Access Compliance Report

Public Rights-of-Way

(Curb Ramps)

Intersection ID: 42952	Main Street: LEDSON_CT	Cross Street: LONG_PAW_LN	Location: NW
ADA ID: EE3272120A63	Ramp Type: Perp	Initial Pass/Fail: Pass	Overall Compliance: No
Severity Score: 5			
Codes/Mitigation Info/Possible Solution		Field Measurements/Component Compliance

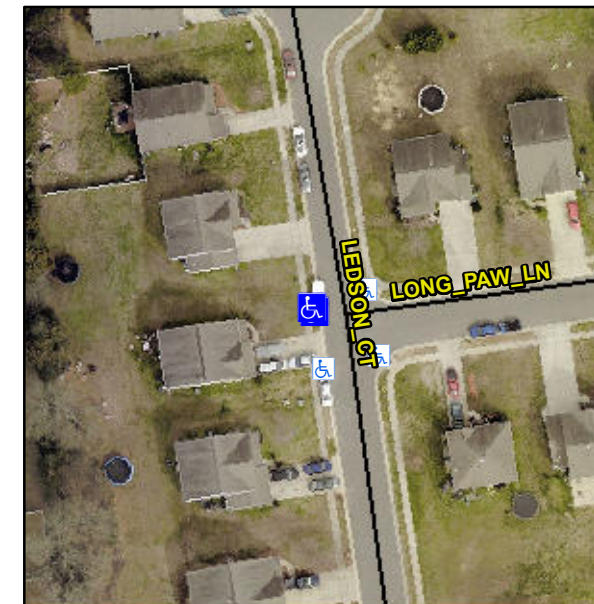
Not Found, R304.5.4

**Remove & Replace Entire Ramp.
Remove & Replace Gutter.**
